January 19, 2024

**Re: Horse Heaven Wind Project – Applicant Comments and Concerns on EFSEC  
Proposed Final Action, January 24, 2024**

# Attachment F

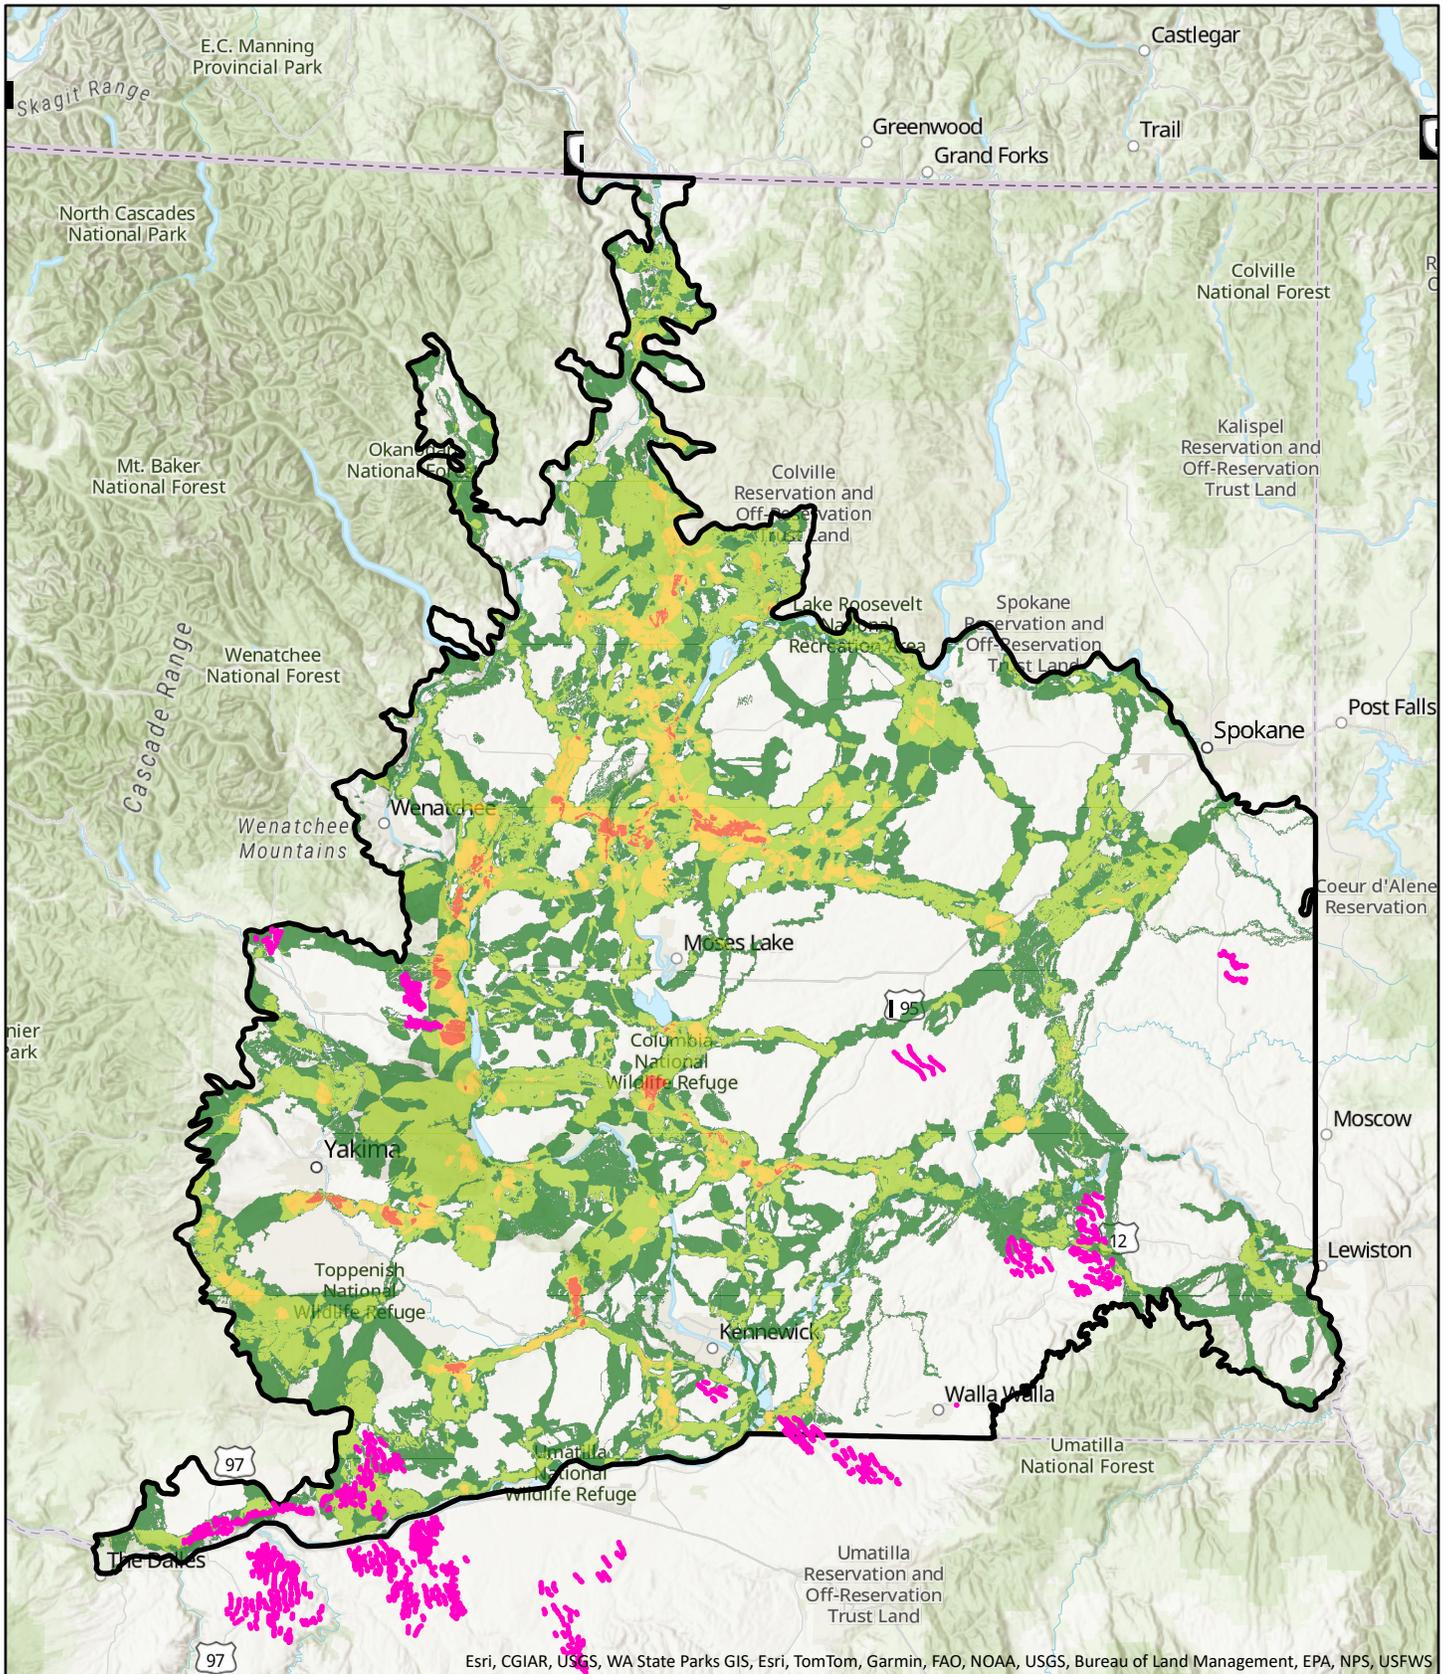
<sup>15</sup> See Attachment F, showing areas of State affected by movement corridor classifications.

# Attachment G

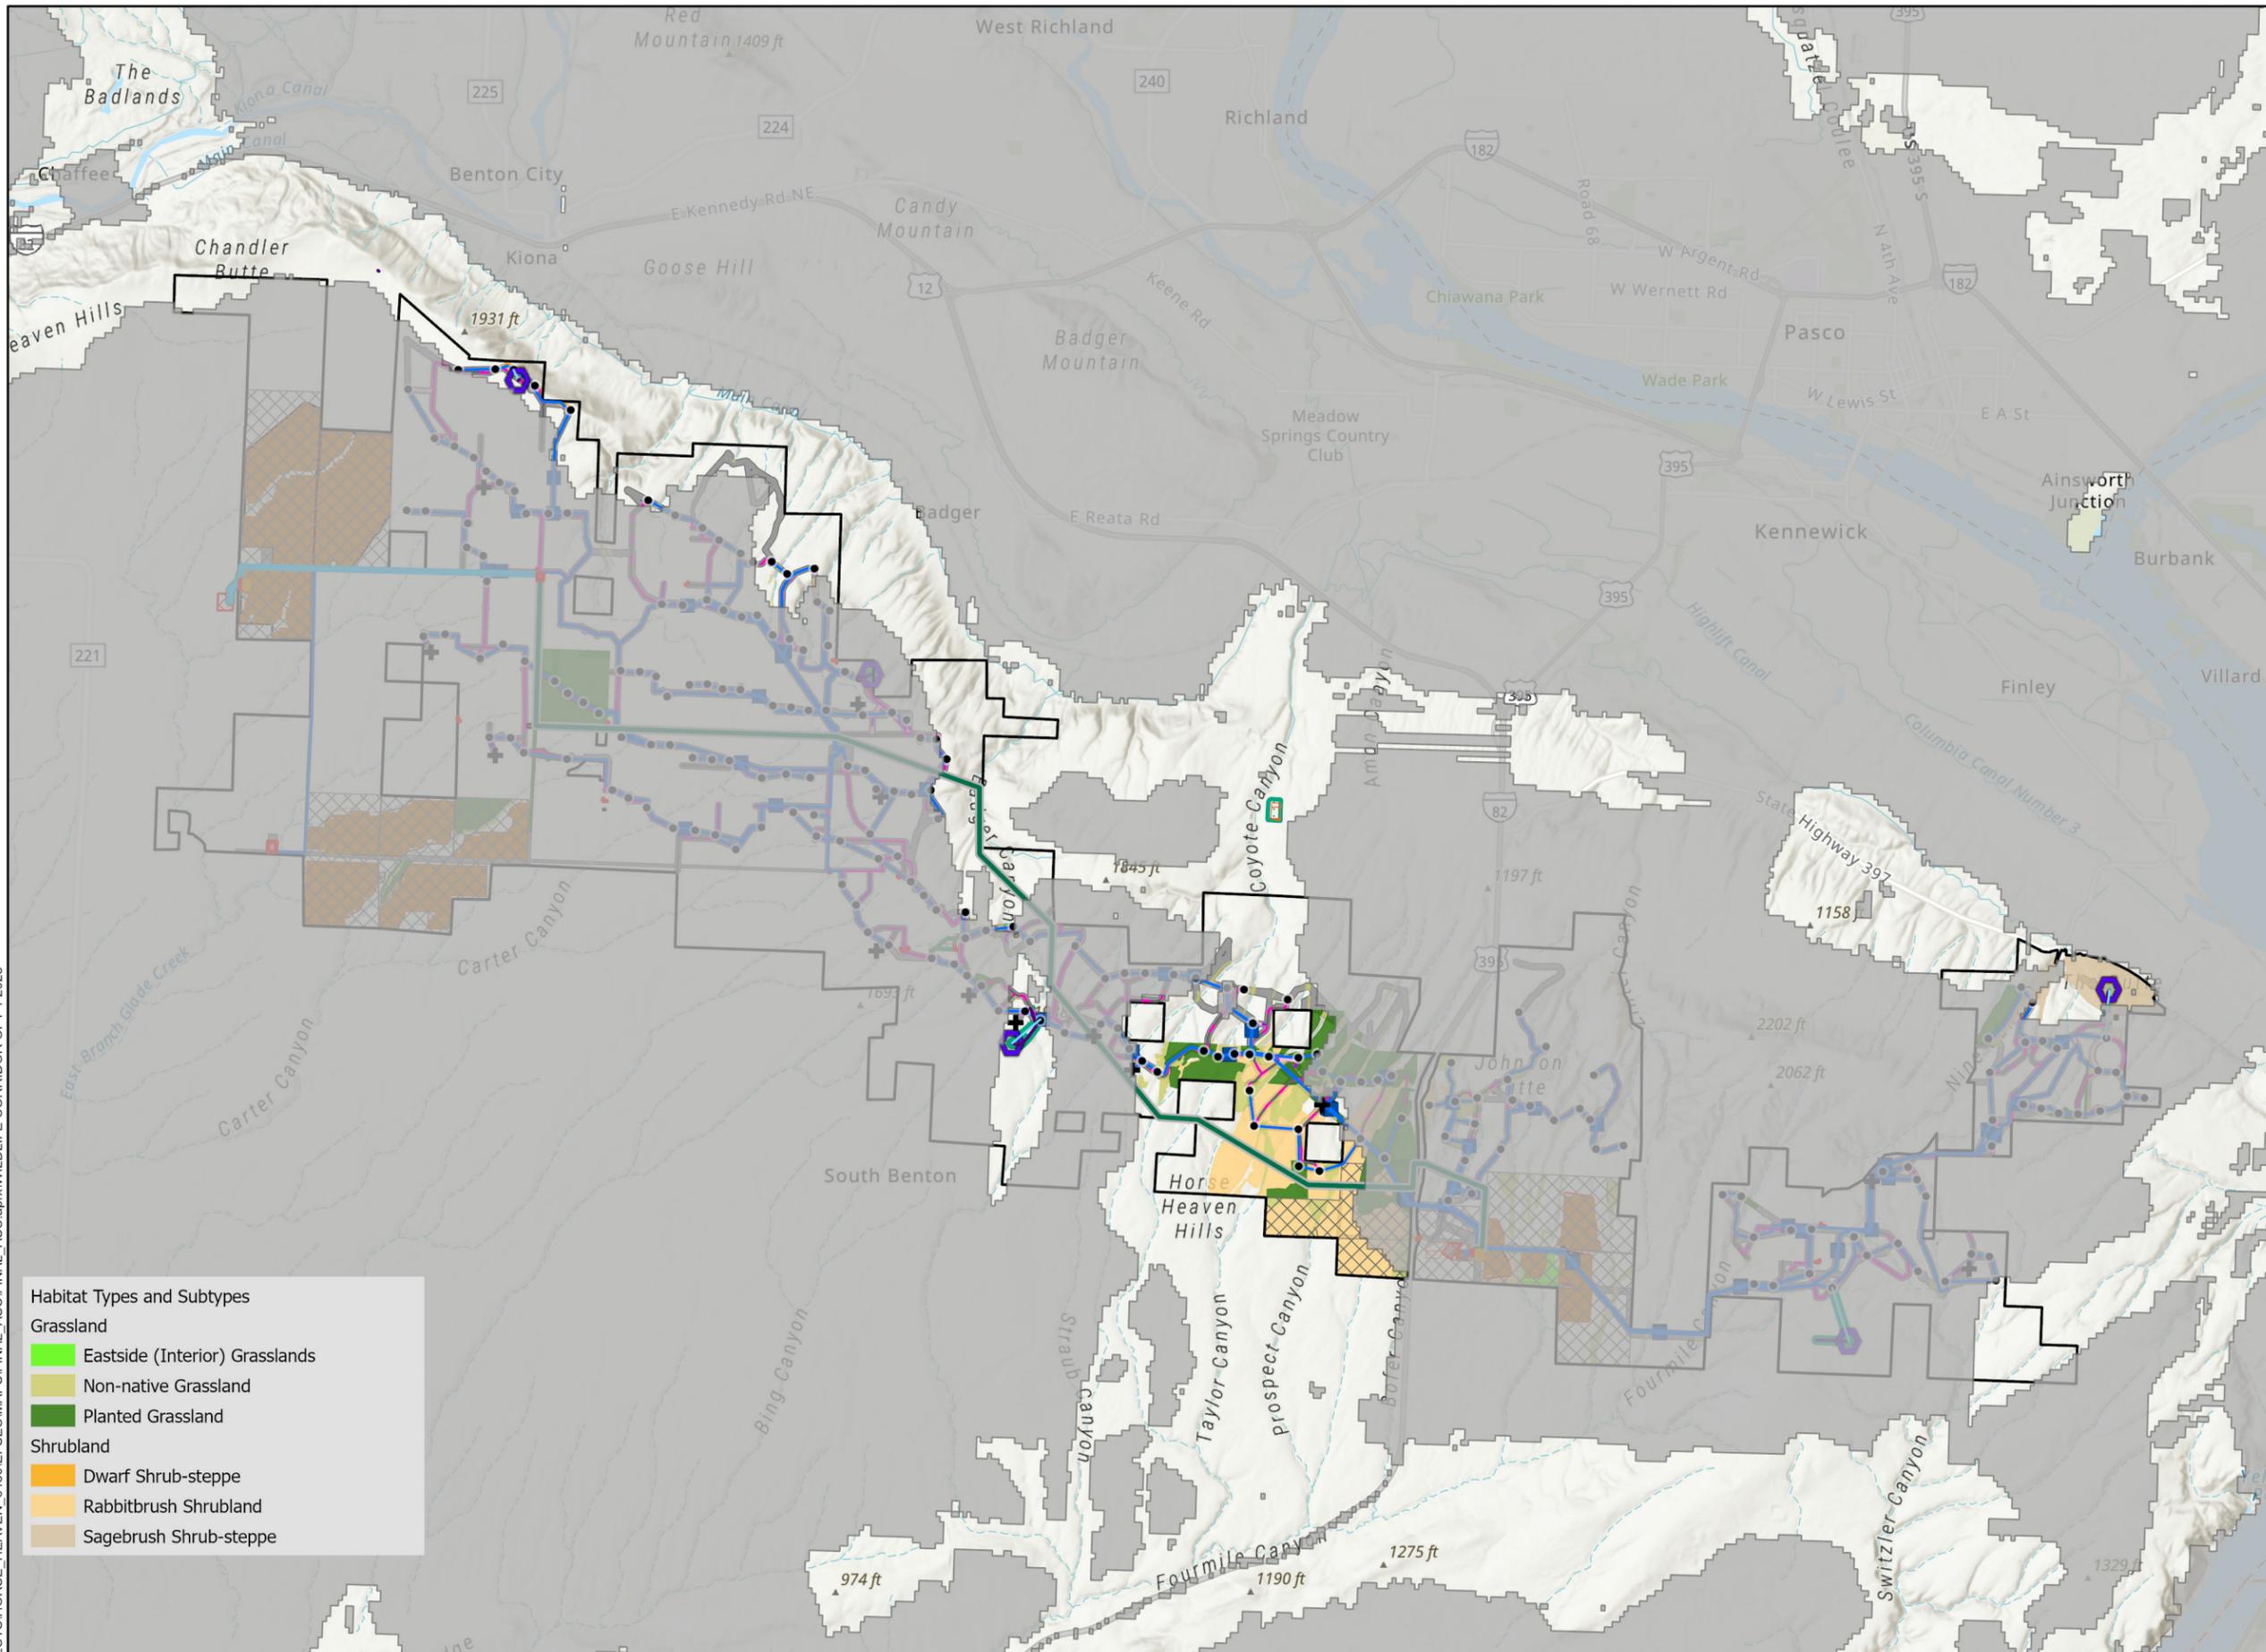
<sup>14</sup> See Attachment G, depicting Project area impacted by wildlife movement corridor classifications medium to very high linkage.
